RE: BZA Case No. 20382, Parties in Opposition Joint Statement

- The Applicant is requesting special exception relief to build a 2-level garage addition, a rooftop popup, and a rooftop deck (the “Project”). The Applicant is requesting the Board to grant all of the three types of relief allowed under 11-E DCMR § 5201.2 to: increase the lot occupancy to 69.8%, waive the alley center line setback to 3 ft. 4 in., and increase existing non-conforming aspects of the garage and house.

Drawing 4 - Graphical representation of proposed 2-level garage addition.
View from the neighbor's backyard.

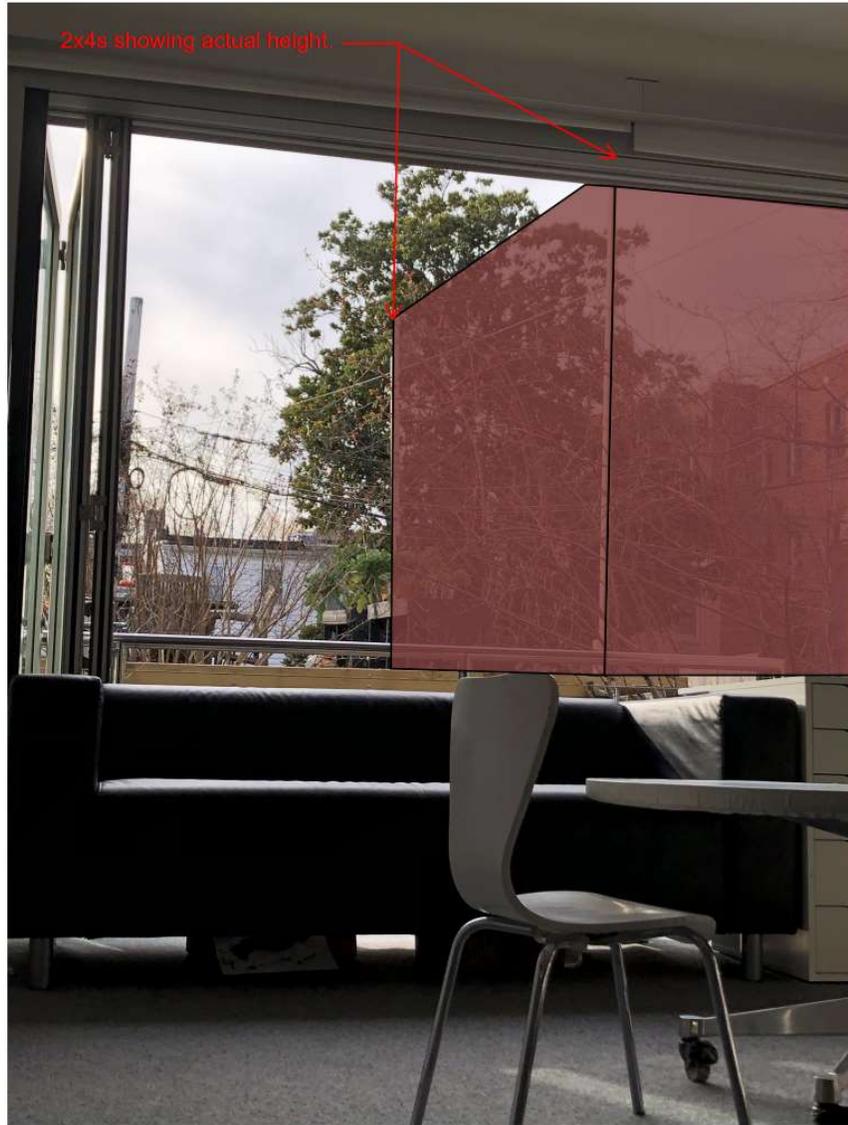
- The portion of the 20 ft. wall of the 2-level garage addition that will extend directly above our garage may retain and reflect such a substantial amount of heat during the summer months, such that it will unduly affect the temperature in our garage during the

Drawing 5 - Graphical representation of proposed 2-level garage addition. View from the neighbor's level 1 living room showing a substantial impact on the neighbor's access to light and air.

Drawing 6

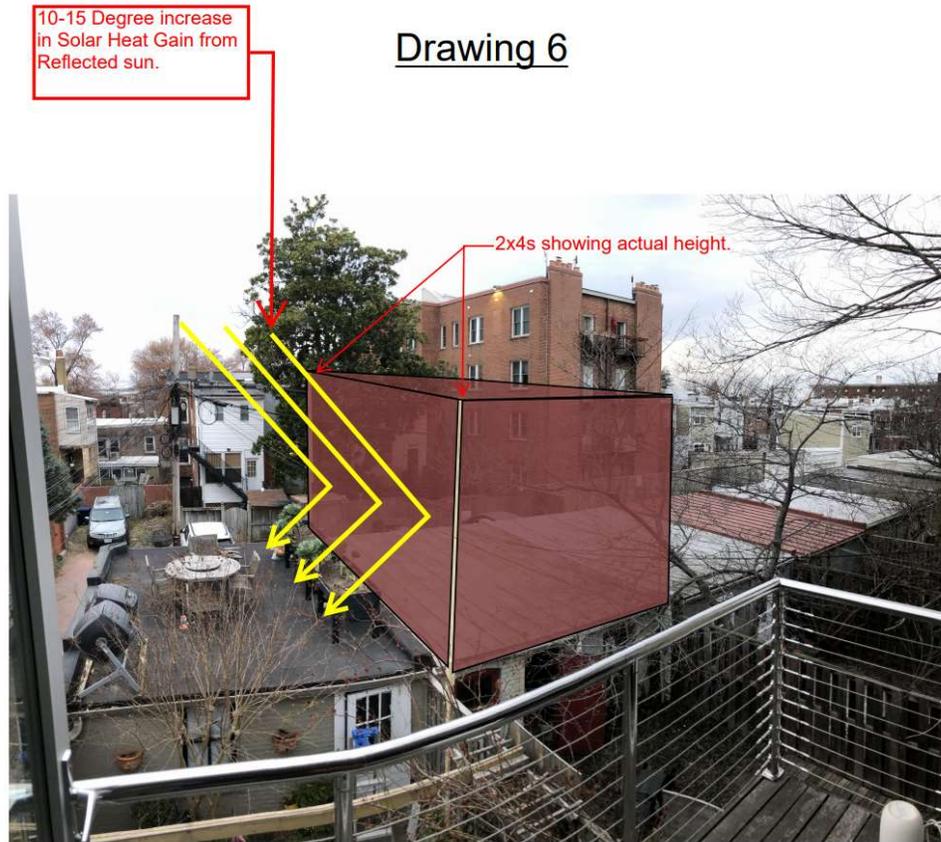
Drawing 6 - Graphical representation of proposed 2-level garage addition. View from the balcony window. The addition will have a substantial negative impact on neighbor's long established usage of their garage roof-top garden patio. There is an anticipated 10-15 degree increase on summer days on this patio due to reflected heat, and a significant decrease in the neighbor's access to light and air.

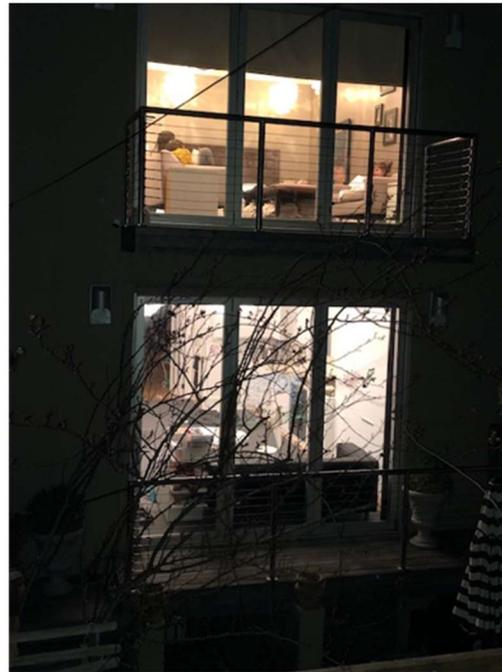
- The Applicant inconceivably concludes that the windows and Juliet balcony on the 2-level garage addition that *directly face the adjoining neighbors' balconies and floor-to-ceiling, wall-to-wall glass doors only approximately 19 feet away* will not unduly compromise the privacy of the adjoining neighbors because "the adjoining neighbors have existing balconies." (Applicant's statement at 7.)

- **The exact opposite is true. The windows and Juliet balcony of the proposed 2-level garage addition will be about 19 feet from the floor-to-ceiling, wall-to-wall, rear glass doors on both levels of the Howell Residence and will look directly into the Howell's main living area on the main level and the master bedroom on the upper level.** This will be particularly invasive with respect to the privacy for the Howell children and in the evening when the lights in the home are on.

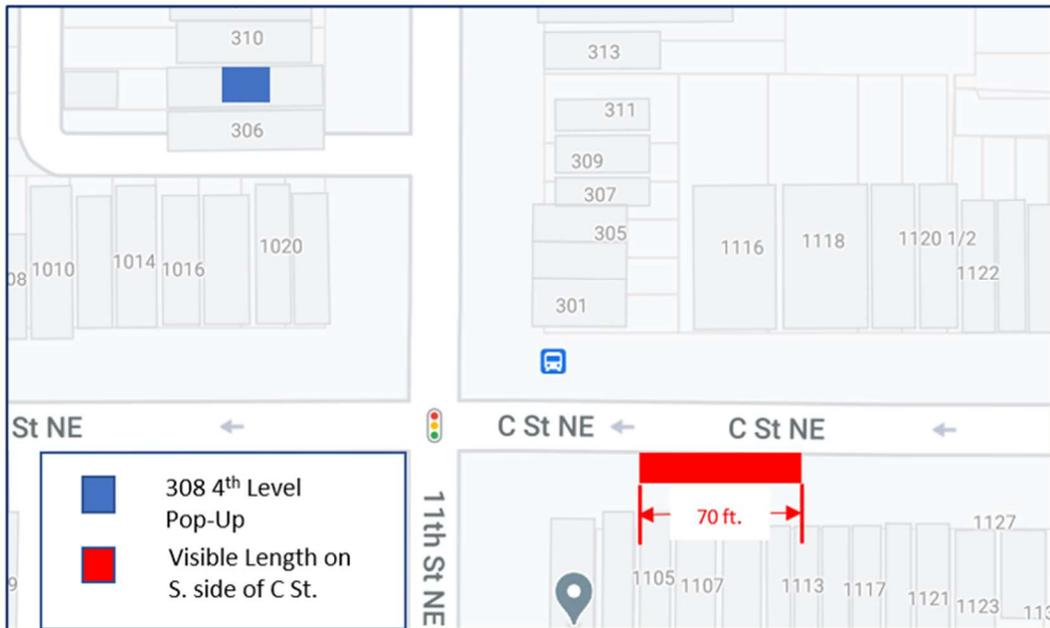
- **The rooftop pop-up will be the first on all four sides of our block and will be viewable for more than 70 feet along the 1100 block of C Street, NE and will provide only about 100 sq. ft. of useable indoor space.**
 - On all four sides of our block—C Street, D Street, 10th Street, and 11th Street in NE—all the row houses are no more than three-levels and are generally consistent in height. There is not a single row house with a rooftop pop-up or even a rooftop deck. The Project’s rooftop pop-up and its deck will be the first of its kind.

- Along the tops of all the homes that span the entire west side of the 300 block of 11th street, the roofline is uniquely uniform, uninterrupted, and level. There are only a few minor interruptions—a few AC units and one home with solar panels. There is no way to refute that the rooftop pop-up, the rooftop deck, and the new rooftop brick wall will permanently destroy and visually intrude on this essentially unaltered roofline.

Drawing 1 - Graphical representation of proposed 2-level garage addition in context of the adjacent garages.

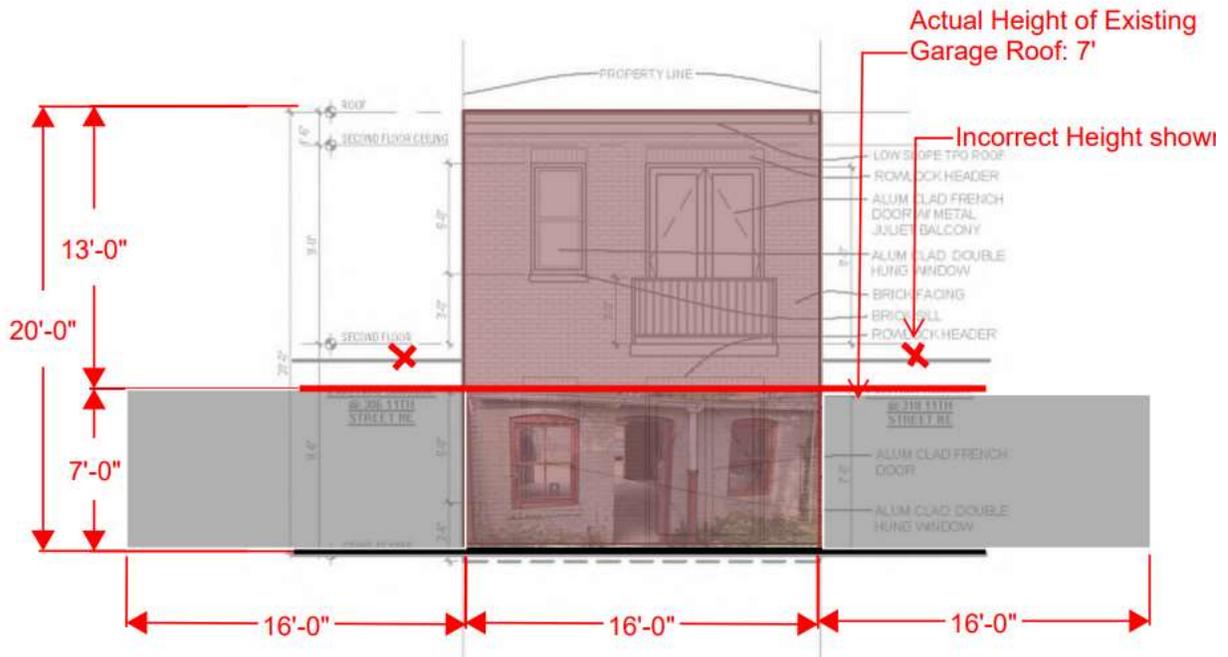
- **The 2-level garage addition will break up a nearly uniform, low-profile pattern of the garages and garage roofline across the entire east side of the alley and will consume more than three times the volume of space to provide a modest 374.6 sq. ft.**

- The existing volume of the garage is 2,283 cu. ft. The volume of the 2-level garage addition will be 7,493 cu. ft. Meaning, it will take *more* than three times the current volume of space to provide a 374.6 sq. ft. room, at a significant and permanent detriment to the quality of life of the neighbors.

Drawing 2 - Graphical representation of proposed 2-level garage addition in context of the adjacent garages.

2 CARRIAGE HOUSE YARD ELEVATION
A-3 SCALE: 1/8"=1'-0"

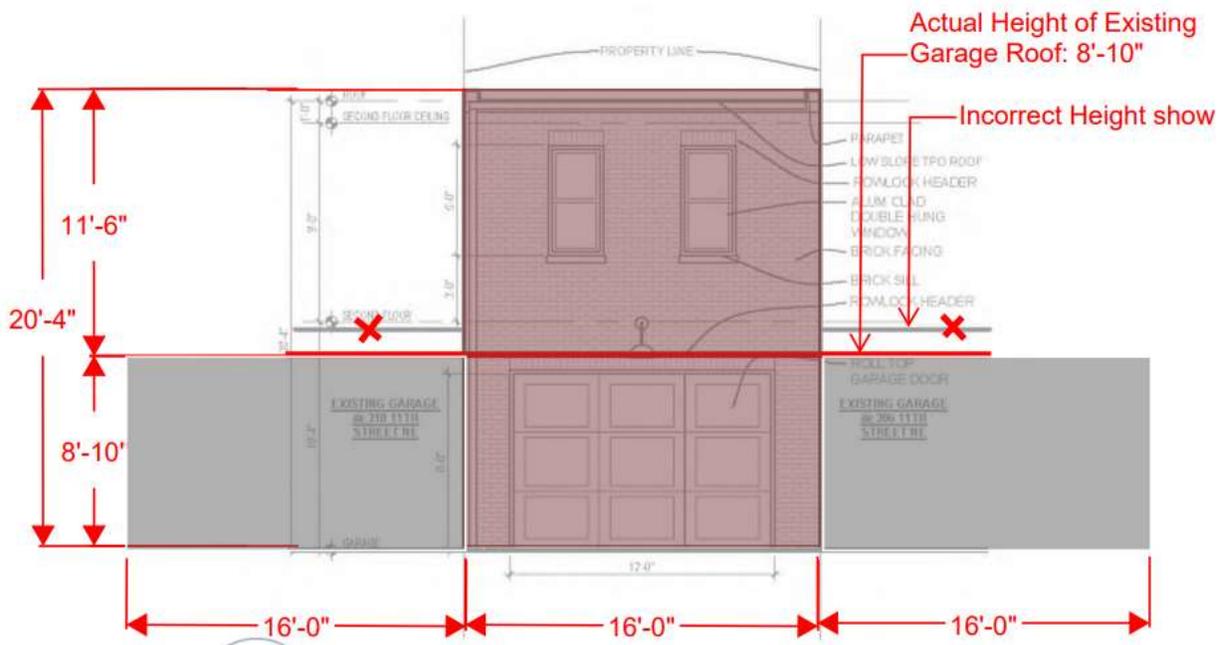
- The Applicant’s drawings similarly minimize the size and scale in relation to the adjacent neighbors and the neighborhood (particularly A-3) by obscuring the height of the 2-level garage addition in relation to the adjacent garages, and by omitting any 3-dimensional drawings showing the actual volume of the structure next to the adjacent properties and rear yards.

- **The Applicant's 2-dimensional drawings of the 2-level garage addition do not accurately show the addition in relation to the abutting garages and nearby properties, and as such, could be characterized as misleading.**
